Casino Winner Technical Bulletin

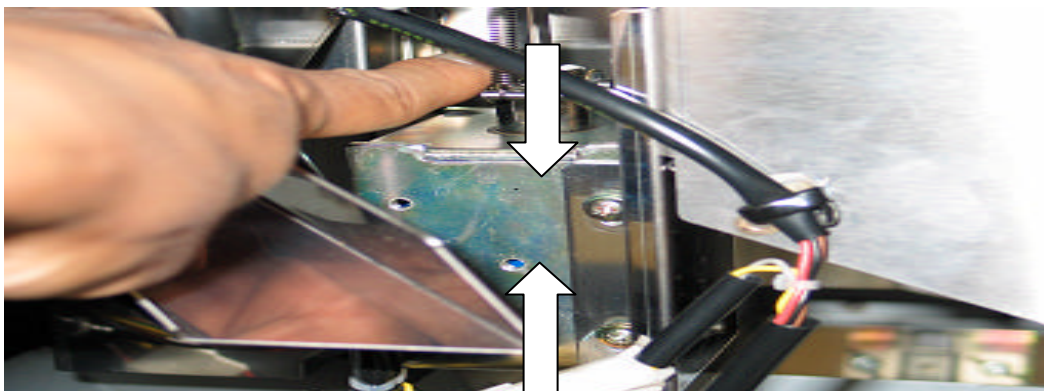
It has come to our attention that a small number of customers have experienced a problem with their new Casino Winner pusher from Brent/Namco whereby error code 5-13 is displayed, causing the machine to lock up until it is reset. We have discovered that the position of the payout solenoid is critical to its effective operation and may need to be adjusted on your machine if this error is experienced. This is a simple operation taking just a few minutes and full instructions are provided below. Please contact our Customer Service dept. on 02083246120 should you require further information.

Please adjust the payout solenoid as follows:

1. Refer to p147 of the operation manual if necessary.
2. Slacken off the two retaining bolts holding the solenoid as shown in the photograph below.

3. While holding down the plunger as shown, bring up the solenoid. When the bottom of the plunger touches the bottom of the solenoid, retighten the two retaining bolts.
